DEVELOPMENT ASSESSMENT REPORT - DA248/14 - PROPOSED SUBDIVISION 1 LOT INTO 12, TWEED ROAD LITHGOW NSW 2790

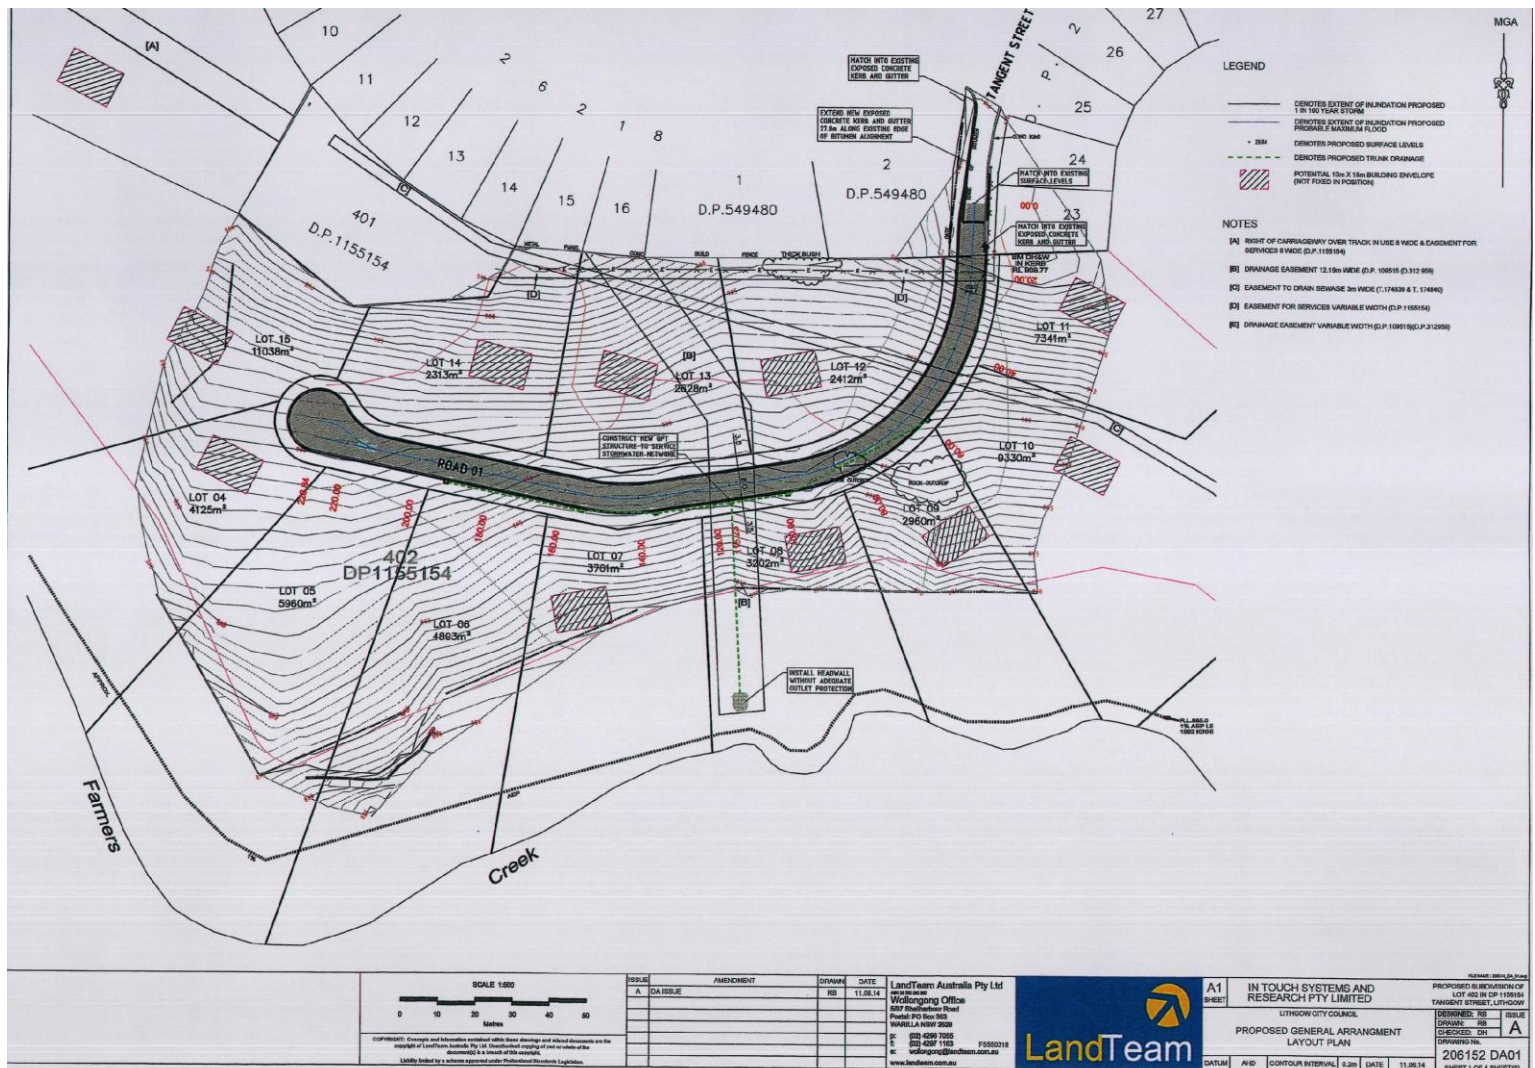
The proposal is for 12 residential allotments with access from a new road extension to Tangent Street, Lithgow with the following lot sizes:

To assess and recommend determination of DA248/14, with the recommendation being for refusal. Council has requested the applicant to submit the following additional information:

1. Provide an indicative sewerage design showing:
Longitudinal sections along the centreline of all sewer mains at scales of 1:500 horizontal and 1:100 vertical. The following details should be included on longitudinal sections for each main:

- (i) Invert, natural surface, and proposed ground surface levels;
 - (ii) Depth from invert to proposed ground surface level;
 - (iii) Chainage along pipe;

- (iv) Pipe gradient, class, diameter, and material;
 - (v) Sewer main and manhole numbers;
 - (vi) Grades should be shown as percentage figures to two decimal places (e.g. 1.25%).

2. Stormwater drainage Line B design information. This includes the longitudinal grade of the pipeline and the design velocity of the stormwater drainage. Council guidelines state that pipes must have a minimum grade of 1% to permit self-cleansing and that flow rates must be a minimum of 0.6m/s and a maximum of 6m/s to prevent cavitation and scouring.

3. Similarly, it is also stated that concrete bulkheads must be constructed for all drainage lines exceeding a grade of 16% at intervals not exceeding 15m in accordance with Council's standard drawing EN 1025. If there are any lines exceeding this maximum grade, this design feature must be noted.

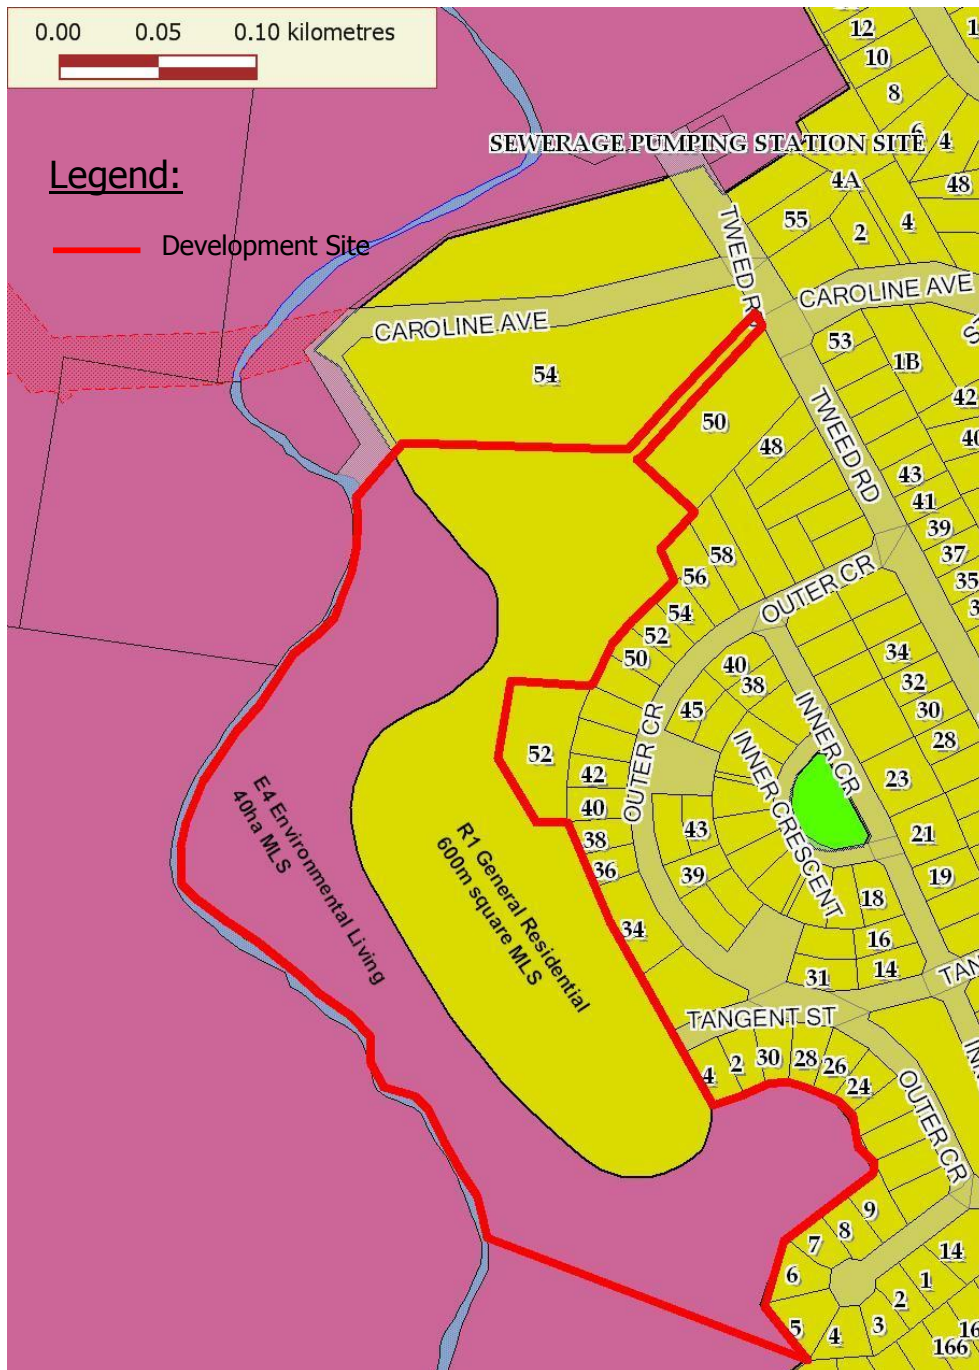
The subdivision does not meet the requirements of Clause 4.1 'Minimum subdivision lot size' for part of the subdivision as the lots require a minimum lot size of 40ha. The remainder of the lot is a minimum lot size of 600m² which is met for this development shown in mapping below. However this clause is not being complied with completely.
